Department of Transportation

MEMORANDUM

SUBJECT: ZC Case No. 12-15C & 15-24B – Gallaudet University Parcels 2 and 3

Figure 1 | Site Plan Comparison – Approved vs. Proposed

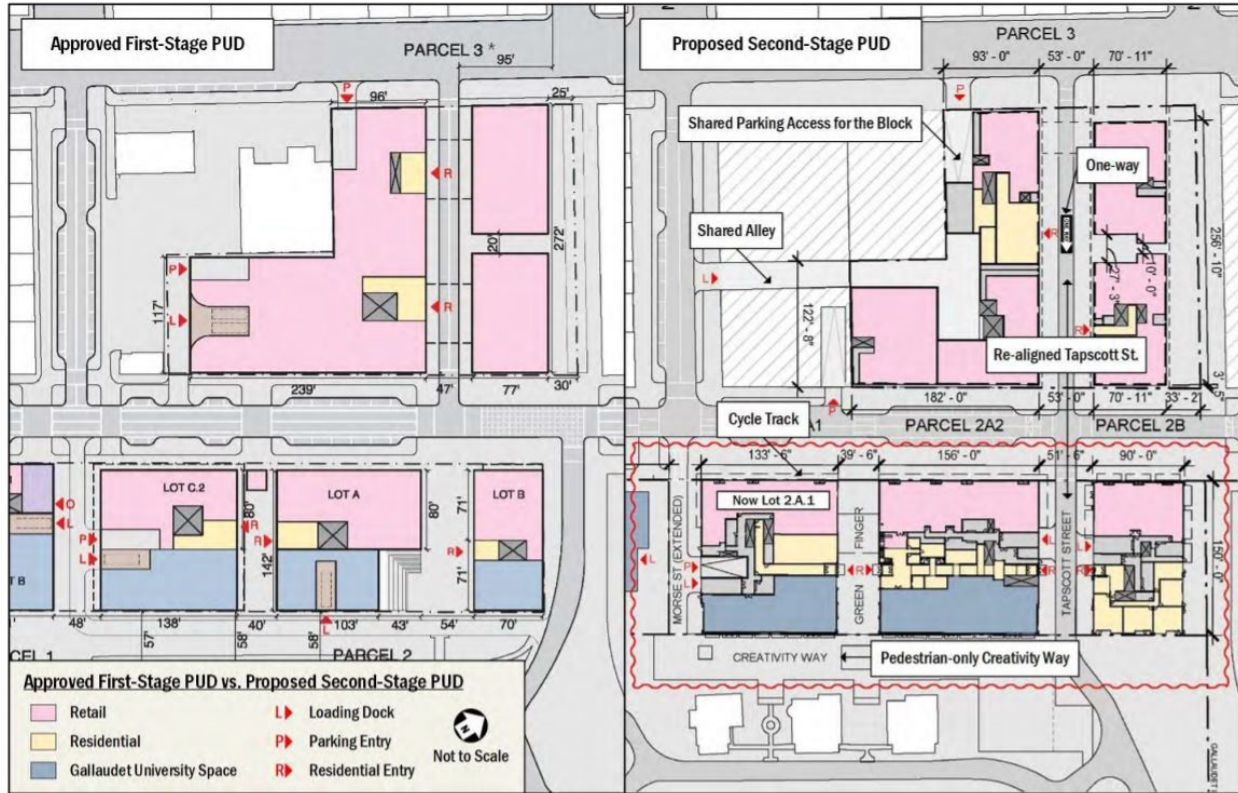
Figure 1 below shows the proposed site layout and access scheme for both Parcels 2 and 3. Vehicular access to the Parcel 2 parking garage will be from Morse Street NE. Loading berths will be accessed from both private Morse Street Extended and realigned private Tapscott Street. The access from Morse Street Extended is consistent with the 1st Stage PUD approval, but the other loading berths are being relocated from Creativity Way to realigned Tapscott Street. DDOT has no objection to this change, however, Urban Forestry noted that there may be some larger trees on the backside of Parcel 2 that could be impacted by the relocation of Tapscott Street. The Applicant should coordinate with the Ward 5 Arborist to schedule a site visit. There are numerous pedestrian entrances to the first-floor retail units along 6th Street. Pedestrian access for the residential and university components will be from Tapscott Street and the green area near the south end of the parcel.

Vehicular access to the Parcel 3 parking garage will be from both 5th Street and 6th Street NE, consistent with the 1st Stage PUD approval. Loading berths will be accessed from the shared access drive from Morse Street NE. In the 1st Stage PUD, the loading berths were accessed via the 6th Street curb cut.

DDOT has no objection to this change. Pedestrian access for Parcel 3 will be from entrances along 5th Street, 6th Street, and Tapscott Street.

Figure 4 | Existing and Future Pedestrian Facilities

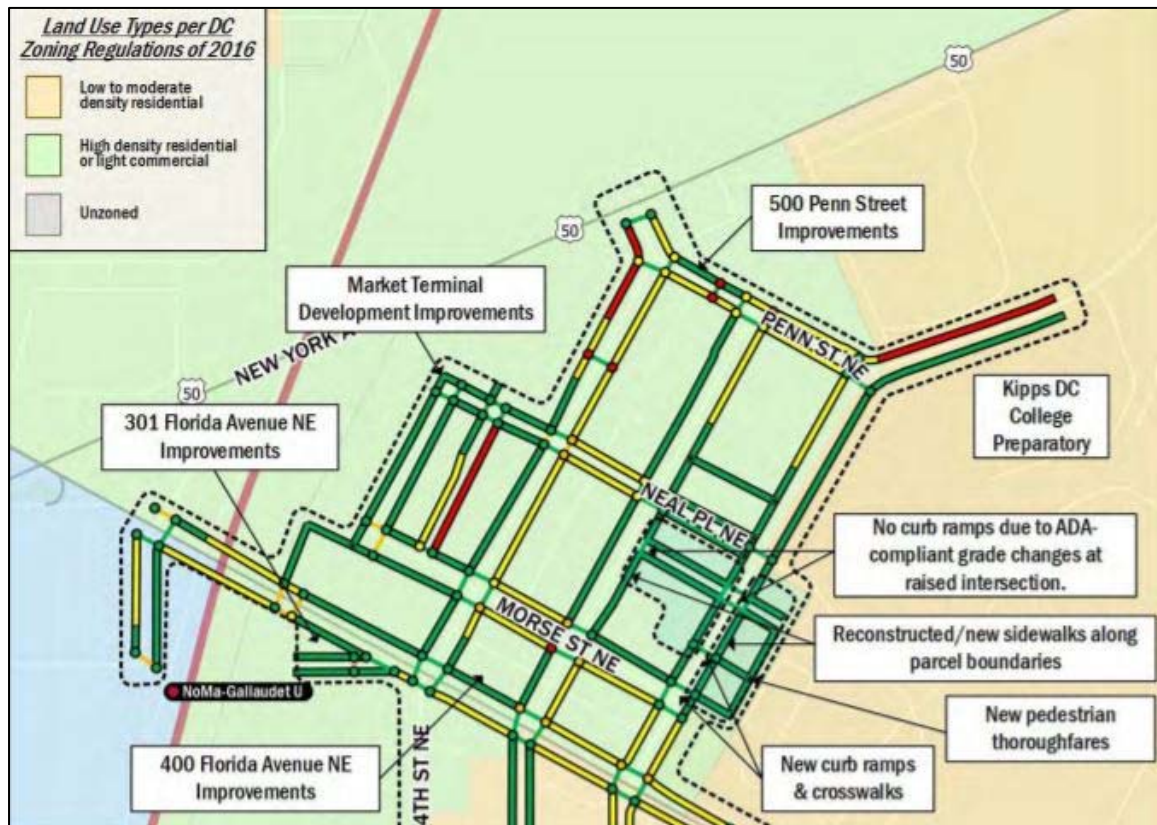
The CTR’s inventory of existing and future pedestrian infrastructure, as shown in Figure 4 below, demonstrates that most sidewalks and curb ramps in the vicinity of the site are currently consistent with DDOT standards or will be after other this and land development projects under construction are completed. While there are a few missing or substandard segments of sidewalk and curb ramps in the

wider area, the existing pedestrian network along major pathways to schools, attractions, and the Metrorail station is generally adequate.
